Staff Report for Administrative Approval

Weber County Planning Division

Application Request:	Consideration and action on a request for design review approval of an office and storage building located at 4770 East 2660 North, Eden UT, 84310
Type of Decision:	Administrative
Applicant:	Philip Castiglia
File Number:	DR 2021-01

Exhibit A – Existing Single-Family Home (Commercial Structure to be Modeled After)

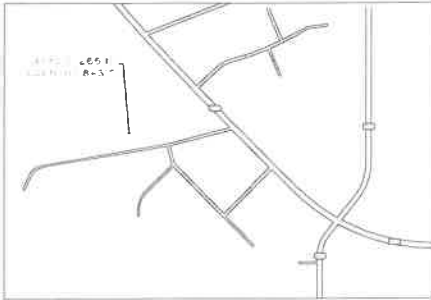
- Per the submitted renderings and photos of the existing home (of which the proposed structure is intended to follow materially and aesthetically), the proposed structure will be primarily clad with a dark grey corrugated steel paneling and black painted I-beams as accents (see **Exhibits A & C**).

- The proposed structure does not incorporate the above listed materials. Corrugated steel sheets have been selected in order to match the existing home on the site. As indicated below, exposed metal is an allowable material so long as it is painted and is non-reflected. To help soften the impact of this material choice, the structure will be screened from the street by trees per the proposed landscaping plan (see page 7 of **Exhibit B**). *It's important to note that the submitted landscaping plan does not specify the type of trees to be planted.*

ELEVATIONS

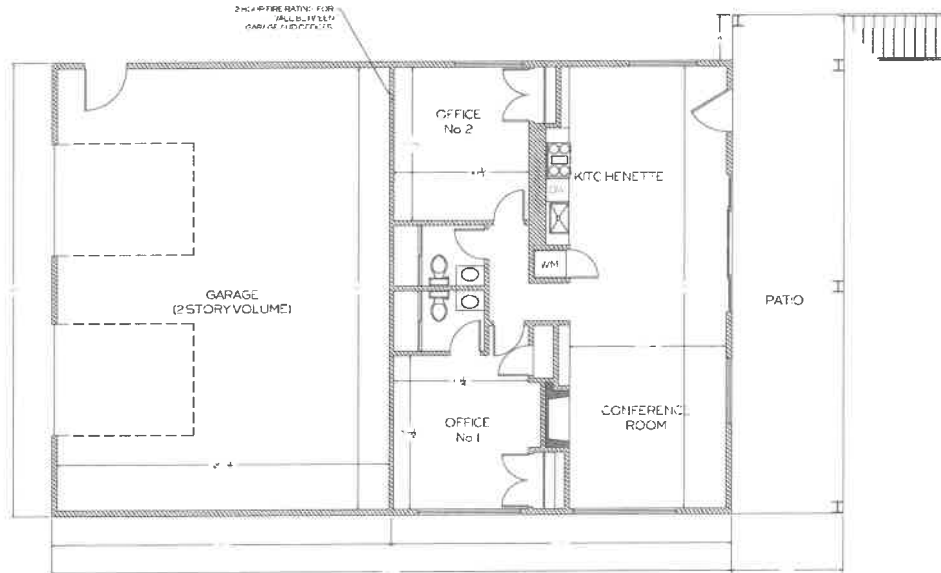
- *Metal windows.* Metal as a window framing support or mounting material shall be painted, stained, anodized or vinyl-clad in approved colors.
 - *The proposed windows will be metal framed and painted a dark grey/black color.*

- *The proposed structure will have a continuous façade of 60' in length.* This façade is broken up by two office windows. This façade will also be screened by the proposed landscaping to help break up the monotonous width of the flat façade.
